STAFF REPORT: 11/16/2022 MEETING PREPARED BY: J. ROSS ADDRESS: 1915 LONGFELLOW APPLICATION NO: #22-8107 HISTORIC DISTRICT: BOSTON-EDISON APPLICANT: JAMES JENKINS JR/JENKINS CONSTRCUTION INC. OWNER: NICHOLAS AND MAYA SMITH DATE OF STAFF SITE VISIT: 10/31/2022 &11/2/2022 DATE OF PROVISIONALLY COMPLETE APPLICATION: 10/17/2022

REPLACE WINDOWS*, INSTALL EGRESS WINDOW, & INSTALL DOOR

The following interior photos of the remaining historic windows that are proposed for removal:

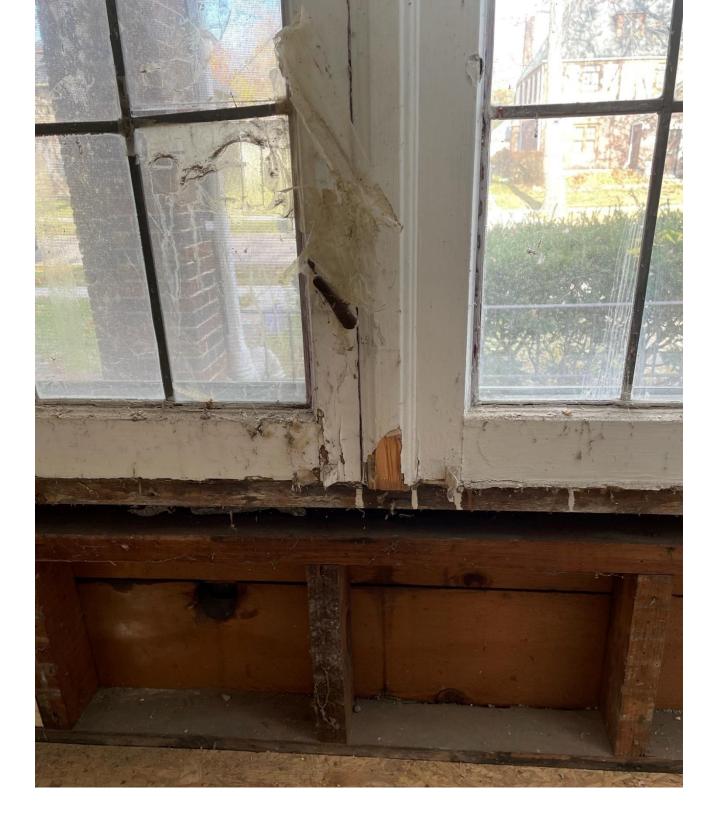
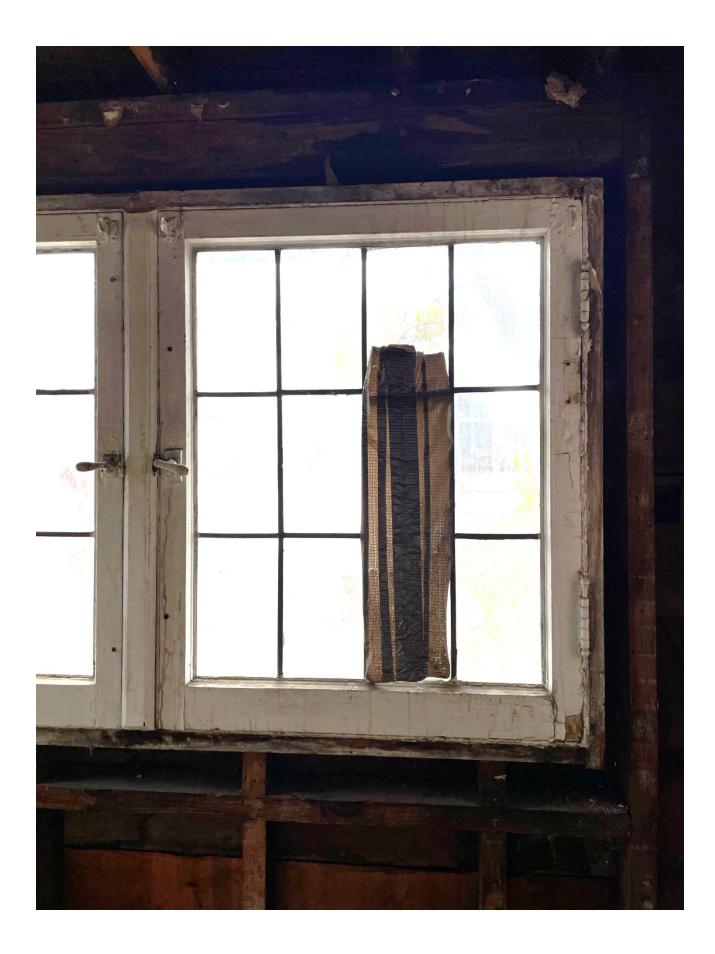
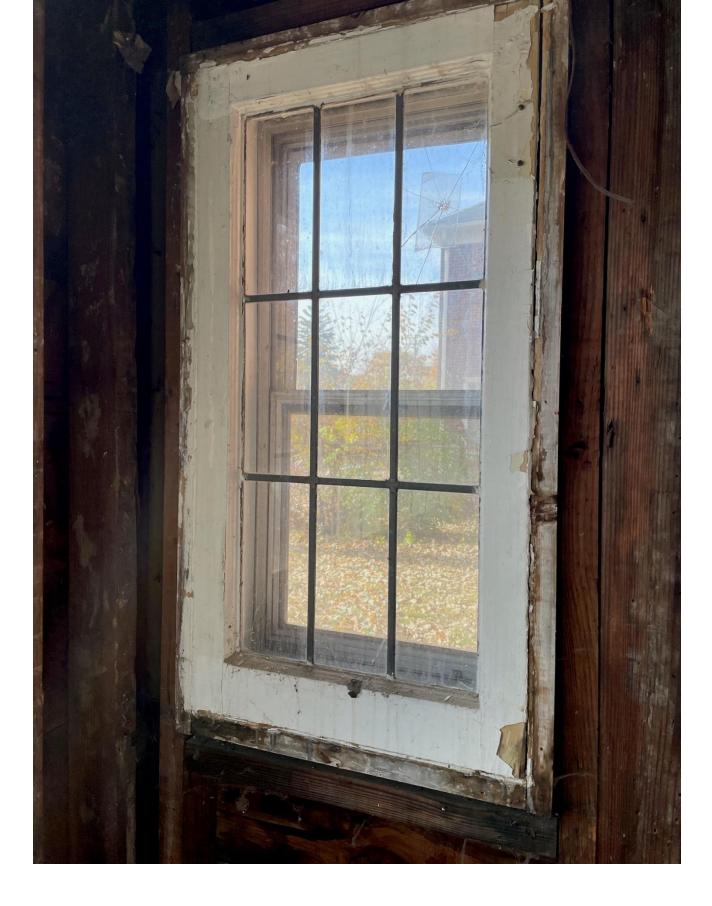
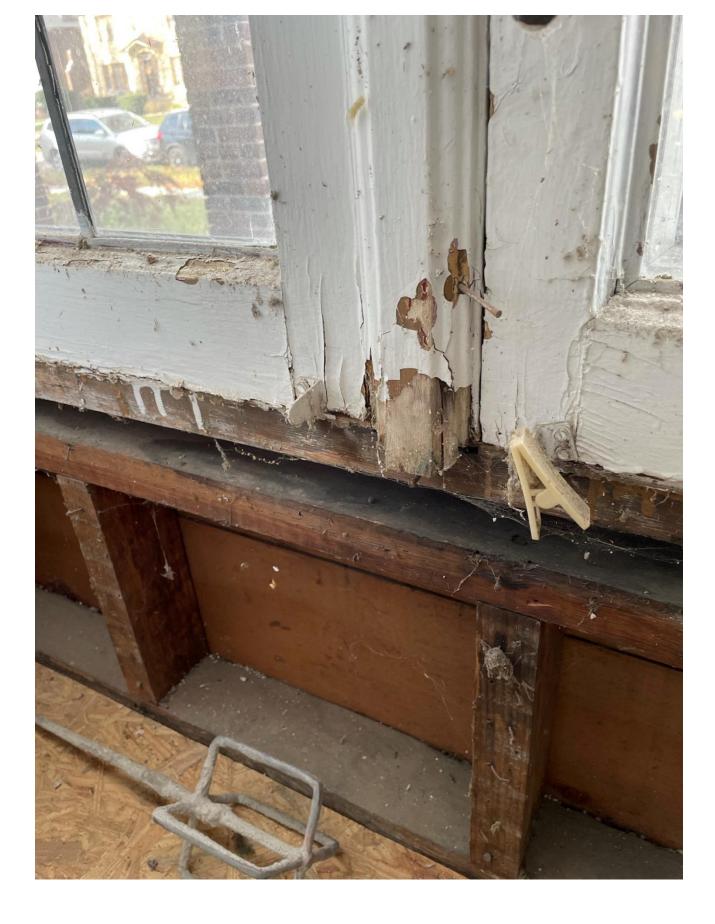
- See the photos of the remaining historic windows at the end of this report. It is staff's opinion that these windows are in fair condition and can be repaired
